Roads and Maritime Reference: SYD15/00729
Council Ref: DA15/1483

PROPOSED MAMRE WEST LAND INVESTIGATION AREA

REVISED ZONING MAP - MAMRE WEST PRECINCT

DRAFT PLANNING CONTROLS FOR MAMRE WEST PRECINCT

FIGURE 6 – ACCESS STRATEGY

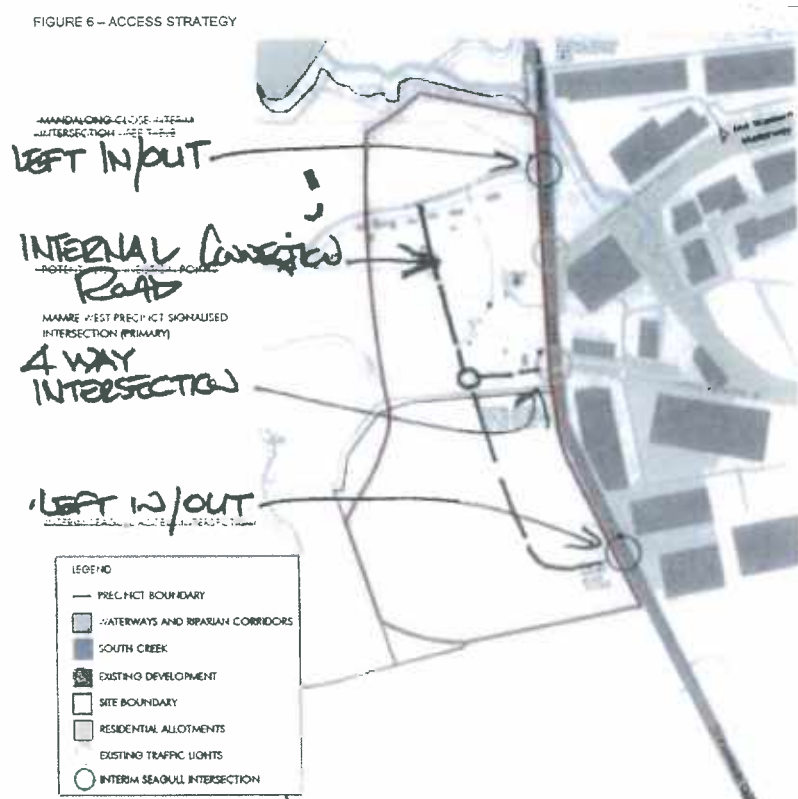
- d) Page 14 – Refer Figure 6 Access Strategy. Consideration should be given to amending this Access Strategy as per **Attachment A** (Mamre Rd Access Strategy) or have short term and long term access strategy diagrams.

- l) Page 15 – Refer Figure 5 Access Strategy consider amending as per **Attachment A** (Mamre Rd Access Strategy) or have short term and long term access strategy diagrams.

3. Roads and Maritime requests that the proposed access strategy for the Mamre West Investigation Area as illustrated in Figure 5 of the exhibited Development Control Plan (DCP) be amended to reflect the access strategy recommended by Roads and Maritime in a letter of 7 January 2016 (**Attachment B**).

In this regard, the access strategy in the final Development Control Plan should depict the proposed southern access on Mamre Road as left in/left out only. Any interim intersection arrangement at this located can be negotiated with Roads and Maritime separately to the DCP process.

ATTACHMENT B – Proposed SP2 Classified Road Zoning

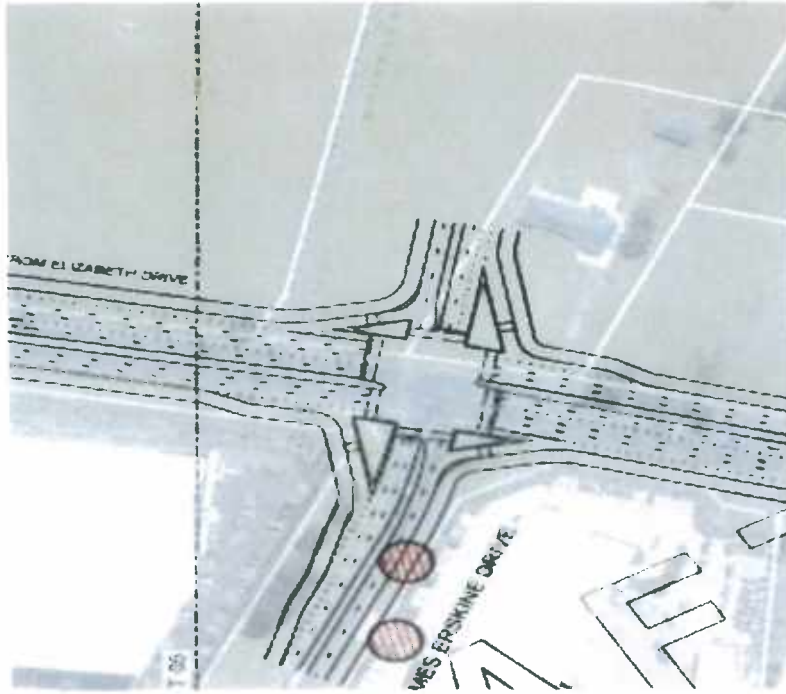
Roads and Maritime do not support the SP2 (Classified Road) zone extending beyond the stub of the signalised intersection on Mamre Road and into the local road network of the IN1 zone of the precinct. In this regard, Roads and Maritime reiterates the advice provided in the previous letter of 7 January 2016 (**Attachment B**) that only the intersection stub is to be zoned SP2 (Classified Road).

Note: Intersection stub only needs to be zoned SP2 (Classified Road) – Refer **Attachment B** - Draft Concept Design for Mamre Rd (**Note: Draft Design is preliminary and subject to change upon further project investigation and design refinement**).

As a result of the above, DoP&E should ensure that the Land Reservation Acquisition Map is amended with the SP2 (Classified Road) zoning applying only to the abovementioned intersection stub.

To assist the Department in identifying the extent of the SP2 (Classified Road) zone at the stub of the intersection, Roads and Maritime provides an indicative road boundary map of the intersection stub in **Attachment C**.
